DEVIATION REVIEW AND DECISION FORM

North Bay at Lake Woodmoor

Section of ECM from Which Deviation is Sought: ECM Section 2.2.4.B.7

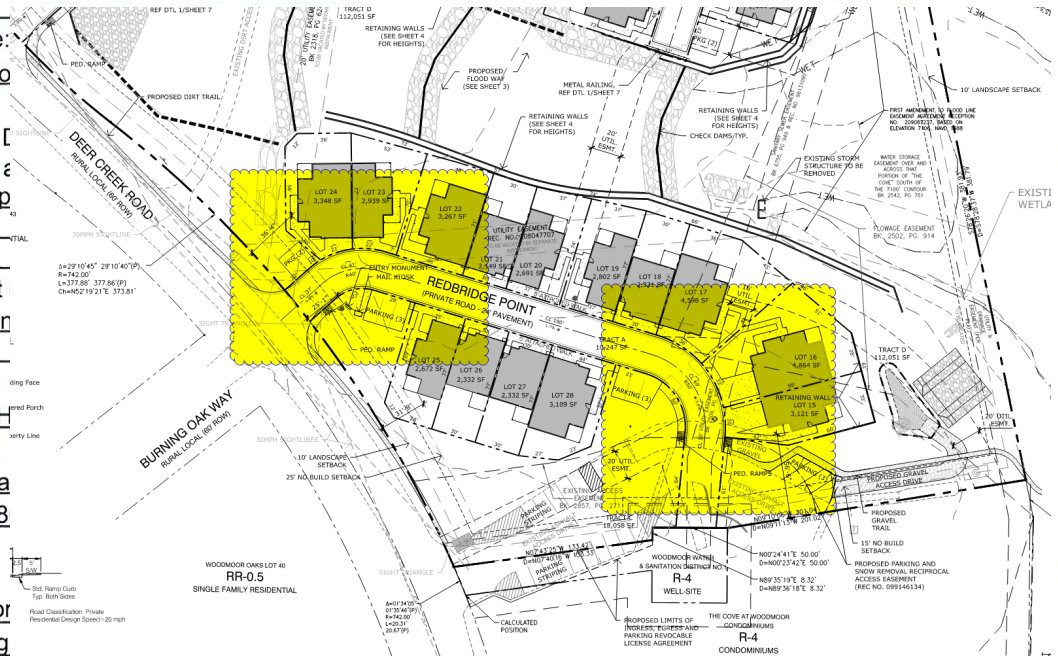
Include a site exhibit highlighting the specific sections of the road where the requested deviation applies. This comment applies for all the deviation request submitted. See the snippet below for example.
